Attachment 1 - PLN17/0655 - 115 Easey Street, Collingwood - Subject site.

PROPOSED FOUR DWELLINGS  
AT 115 EASEY STREET  
COLLINGWOOD

**City of Yarra  
Heritage Advice**

**City of Yarra  
Heritage Advice**

### NORTH ELEVATION

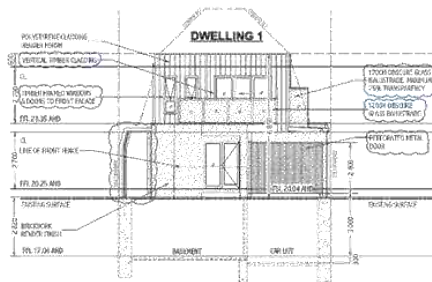
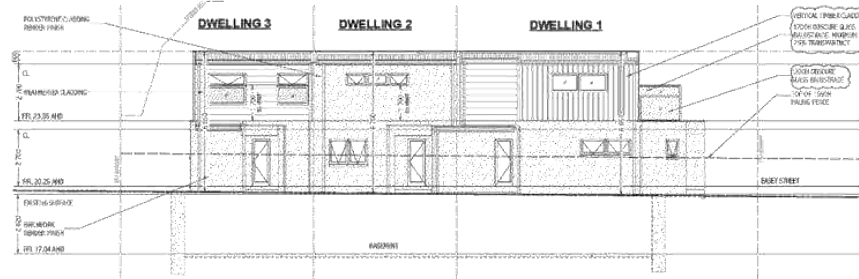
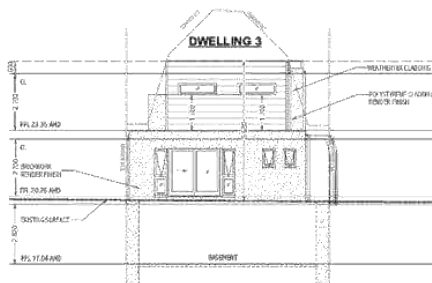
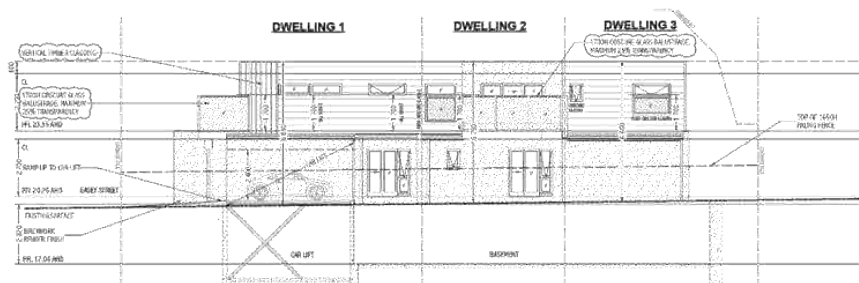
- 1) The proposed window openings in the building's façade are supported as being vertical rectangular and not occupying more than 40% of façade spaces.
- 2) The proposed brickwork with a render finish, and vertical timber battens at the upper level, are supported.

- 3) The proposed 900mm high timber picket fence is supported. **However, the fence should extend across the entire site, including a gate across the driveway.** Including a gate in this location would help to 'contain' the non-contributory site, making it more visually recessive, and retain a traditional vista within the streetscape where carparking and driveways are not an original feature.

- 6) The new proposal includes an open balcony at the front of the building. Whilst enclosed upper level verandahs are traditional for double storey terraces (as per 121 Easey Street), large open balconies with reflective materials are not and detract from surrounding contributory fabric – especially once furniture and activity occupy the balcony.

**It is strongly recommended that the street-facing balcony be deleted from dwelling 1; or reduced in size (8sqm max) and the balustrade material changed to timber to complement façade cladding and conceal furniture/activity behind.**

**Perforated Metal Garage Door**

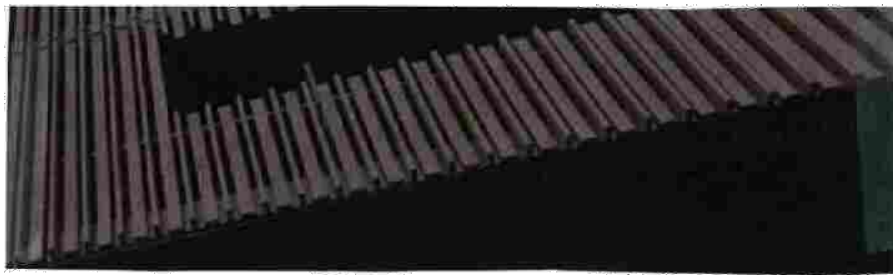
- 4) Landscaping in the front garden is supported.
- 5) The proposed perforated mesh garage door would be highly contemporary and out of character with the traditional streetscape. **It is strongly recommended that the perforated mesh garage door be substituted for a matte finished material such as timber.**
